Preferred Project Report Modification to Concept Plan

Frasers Broadway (Formerly CUB Site)

Submitted to
Department of Planning
On Behalf of Frasers Broadway Pty Ltd

October 2008 ■ 08084

Figure 1 – Block 4a Building Height Transition – Abercrombie Street Elevation

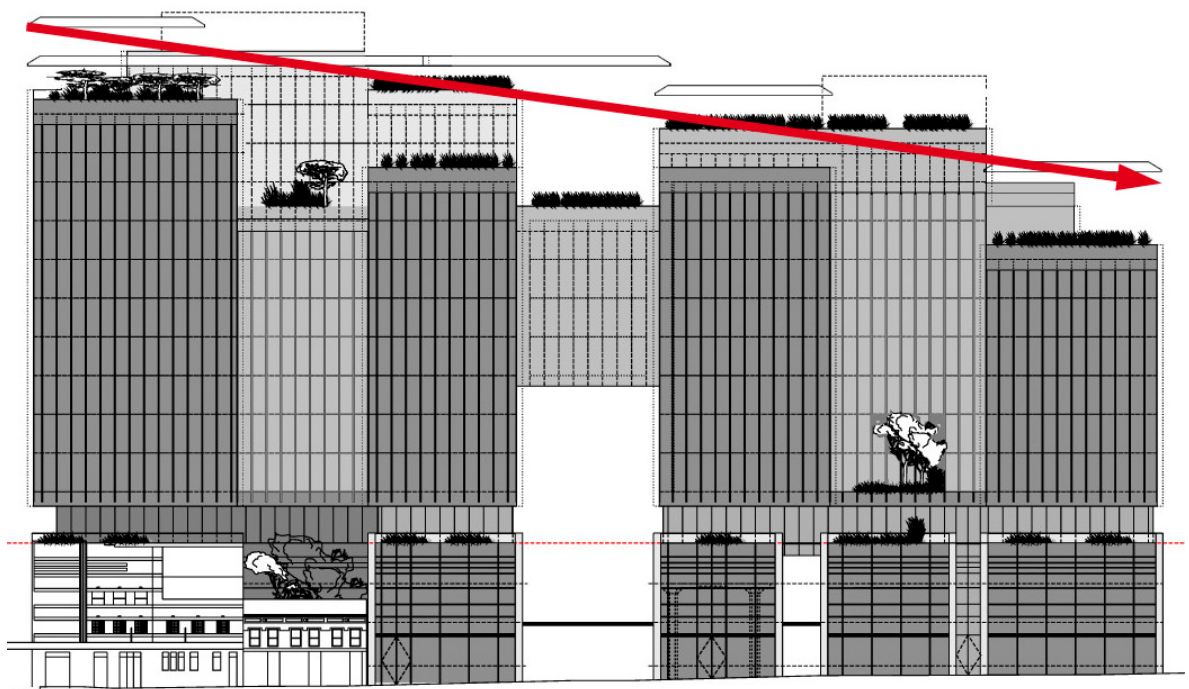
"The massing along Abercrombie Street should be addressed in the context of the surrounding area. This may involve addressing height, bulk, scale and setbacks of the building in this location."

The Building envelope for Blocks 1 + 4a has been revised by Foster + Partners. The revised envelope steps down in height from the corner of Broadway and Abercrombie Streets towards the south, providing a greater transition in building height from Broadway to Chippendale. The overall building envelope has also been broken up to now read as three main building elements connected by linking bridges at the mid to upper levels. Cross sections showing the revised built form of Blocks 1 + 4 are in Plans A-1400 and A-1403 in **Appendix A**. A preliminary elevation showing the building height transition along Abercrombie Street is shown in **Figure 1** below. **Figure 2** shows the proposed massing of Blocks 1 and 4.

Figure 8 – View Carlton Street northwards – revised design

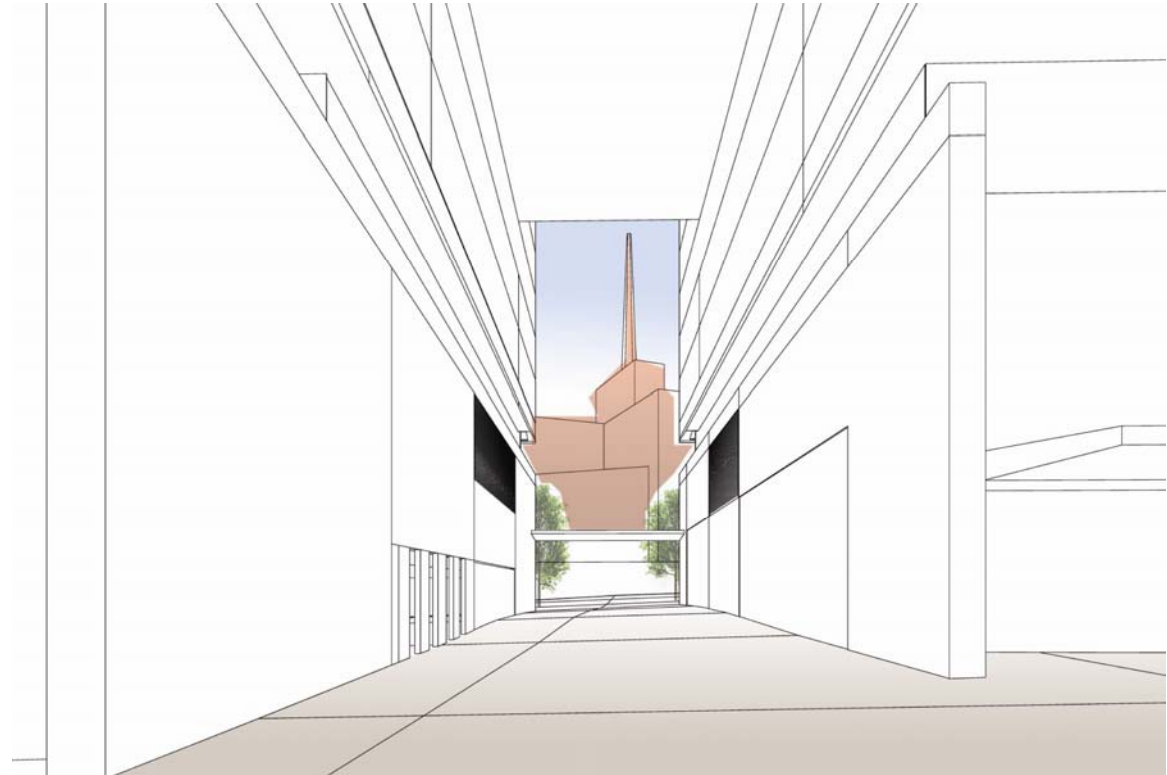
“The pedestrian link to Abercrombie Street from Carlton Street should be amended to improve permeability and vistas between the Brewery Yard / Chimney Stack and the adjoining heritage items (Blackfriars / St Benedict’s Presbytery Church).”

The publicly accessible throughways through Blocks 1 + 4 have been widened and increased in height to improve visual and pedestrian connectivity between Abercrombie Street, Broadway and the interior of the site, in particular views and access to and from the heritage Brewery Yard. Revised view perspectives compared with the submitted modification are shown at **Figures 3 to 8**.

Figure 9 – Artist Impression of Block 2a Plates looking east along Tooth Avenue.

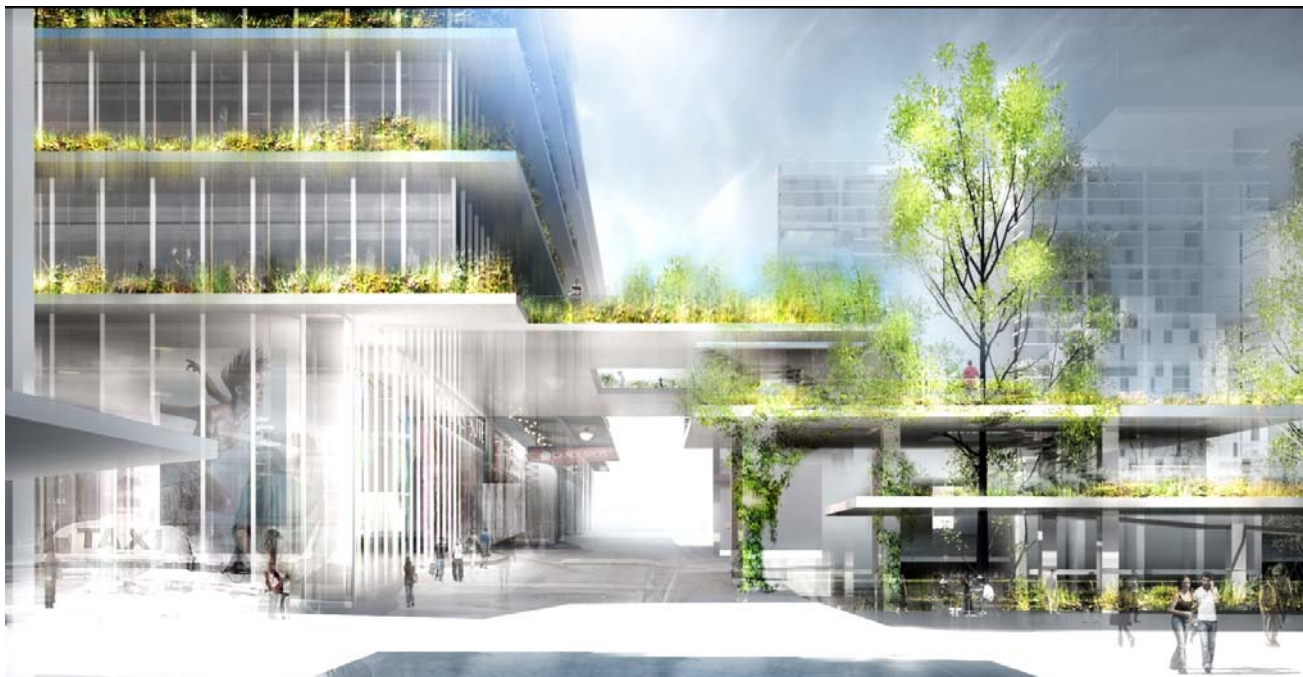
“The project building elements/elevated terraces over Carlton Road [We have assumed the DoP is referring to Tooth Avenue which is immediately south of Block 2 and not Carlton Lane] at the rear (south) of Block 2 detracts from the through views and permeability between Kent Road to Abercrombie Street over this part of the site. These elements should be reconsidered.”

The “Green Plates” are an important element in the overall design and function of the site. The plates form a series of landscaped platforms that provide a direct pedestrian link from the public domain over Tooth Lane and up to the podium of Building 2. As shown in **Figures 4** and **9**, the platform over Tooth Lane will be the equivalent of three storeys above the carriage way. The plate will also contain openings above the street to allow light penetration to the area below, further opening up the area visually.

Figure 10 – Block 6 Revisions – Cross Section

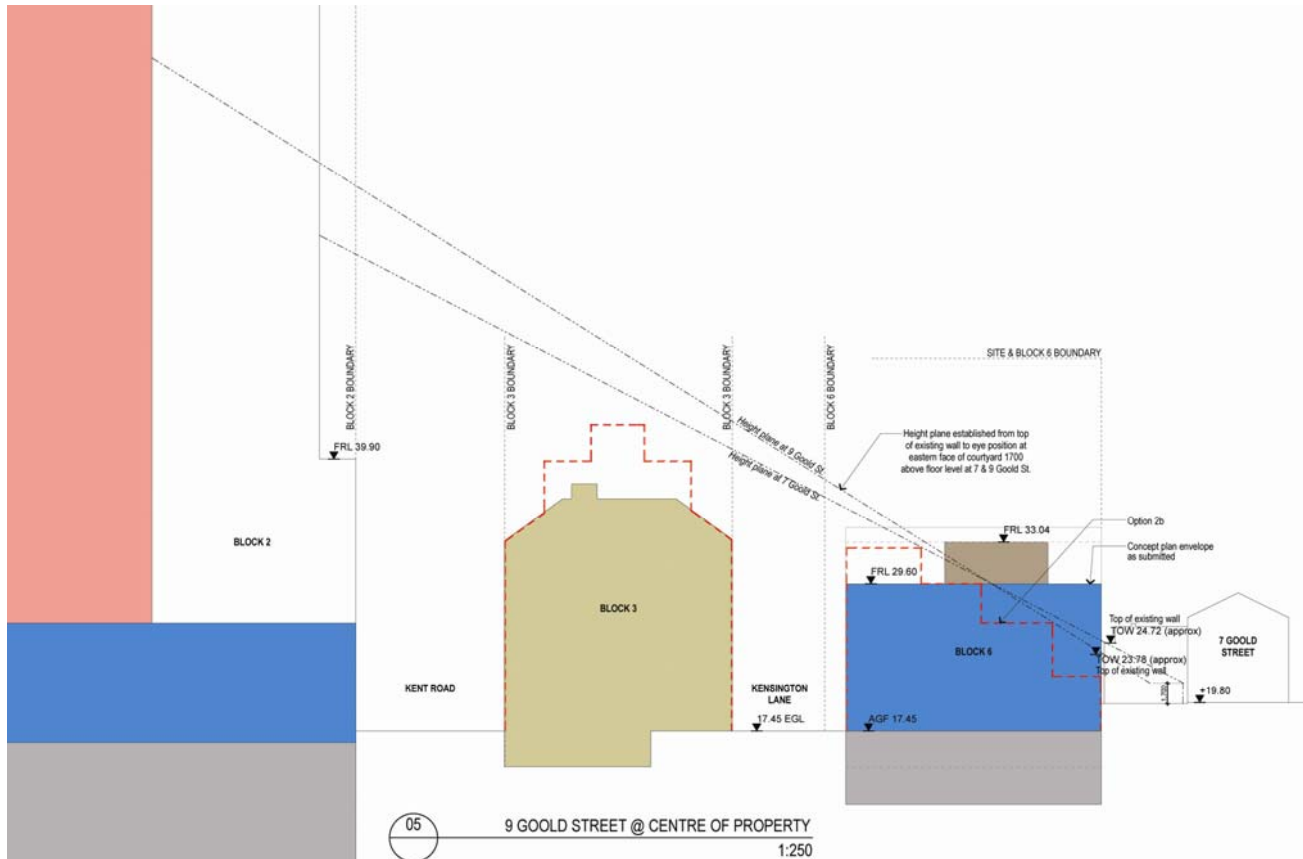
The height, bulk and scale of Block 6 should be reduced to better relate to the pattern of existing bulk/scale of heritage buildings in Kensington Street.

The height and scale of Block 6 is considered to be consistent with the surrounding built form context. Similar or higher building forms adjoin the site to the west across Kensington Street (Block 3) and to the rear on Dwyer Street. Notwithstanding this, the rear of the Block 6 building has been amended to step back from the existing 2 storey dwellings in Goold Street to maintain the height plane from the rear of the dwellings to the existing structures on the site. A cross section showing the relationship of the proposed Block 6 envelope with properties at the rear on Goold Street is shown in **Figures 10 and 11**.

Figure 12 – Proposed (green) and approved (red) massing on the site viewed from north east.

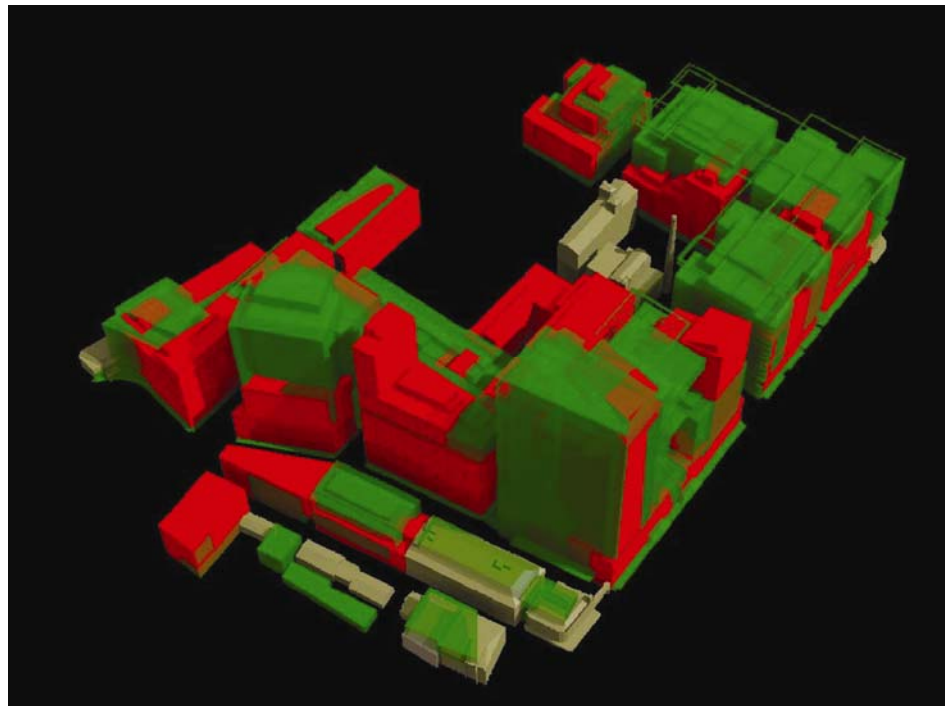
“A full set of scaled (minimum A3 size) elevations and section plans of the approval (including height plane) overlaid by the proposed modification (using colour differentiation).”

Plan A-2010 shows a 3-D representation of the changes to massing on the site. **Figures 12 and 13** below show the proposed massing (green) and approved (red) for the site when viewed from the north-east and south-west.
